Access Compliance Report Public Rights-of-Way (Curb Ramps)

Main Street: SNAPDRAGON_ST Cross Street: BLUE_SPRUCE_DR Location: E

ADA ID: RPRK211109124013 Ramp Type: Type 4 - Parallel Initial Pass/Fail: Pass Overall Compliance: No Severity Score: 25

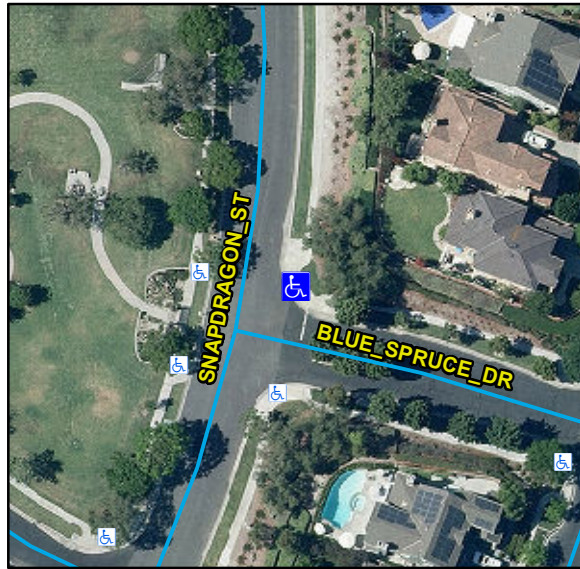
N/A	Ramp Inside Crosswalk 1	N/A	N/A	Ramp Inside Crosswalk 2	N/A
	Crossing 1 Slope (%)	3		Crossing 2 Slope (%)	2.4
	Crossing 1 Cross Slope (%)	1.7		Crossing 2 Cross Slope (%)	1
Yes	Gutter Ponding	No	Yes	Curb Slope	3.7
Yes	Gutter Lip Height (in)	0		Road Run Slope (%)	2
No	Gutter Run Slope (%)	6.6		Road Cross Slope (%)	1
No	Gutter Cross Slope (%)	2.5	No	Perpendicular Joint Present	No
Yes	Overall Surface Condition	Acceptable			
	Cross Gutter Present?	No		Spandrel Present?	No
	Replace Cross Gutter?	N/A		Replace Spandrel?	N/A

Remove & Replace Curb Ramp With Two New Directional Ramps or Equivalent. Remove & Replace Gutter.
